## PLAN REVIEW SHEET

**Petition:** 2011-073

**Attachments:** 60.04A and 60.07B

STD. NO.	REV.
60.04A

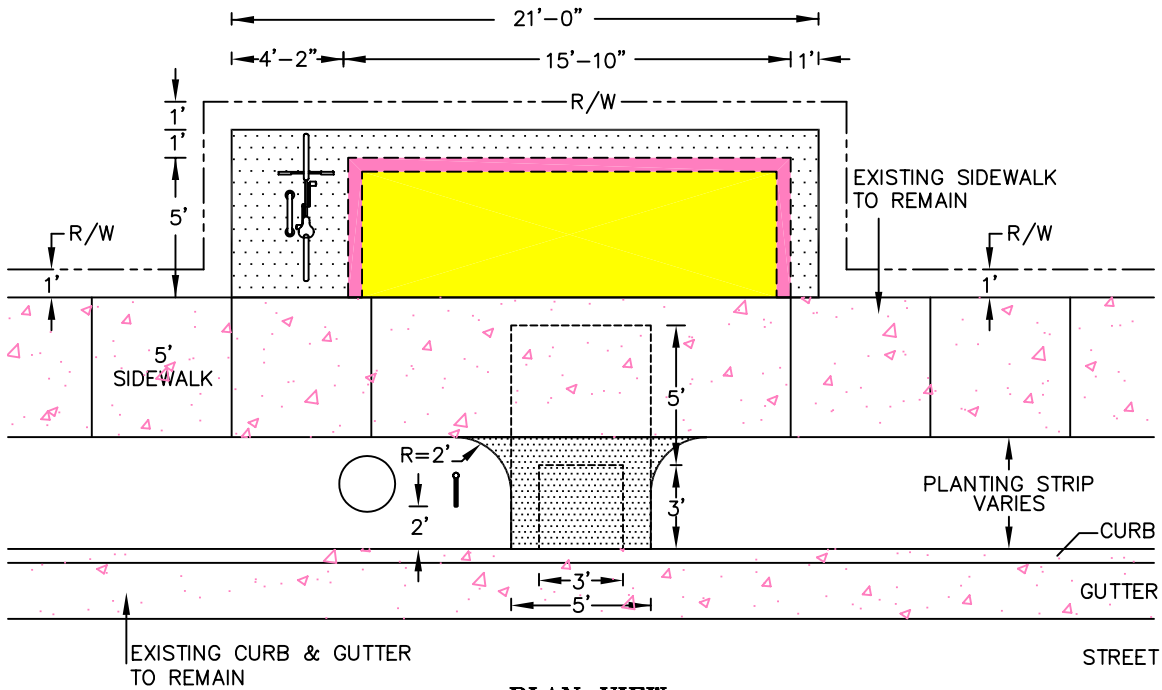
CATS requests that Petitioner install a concrete passenger shelter pad as depicted on the attached. If Petitioner has any questions regarding this request, please contact Ramond Robinson at CATS Service Development, 704.353-0018. Thank you.
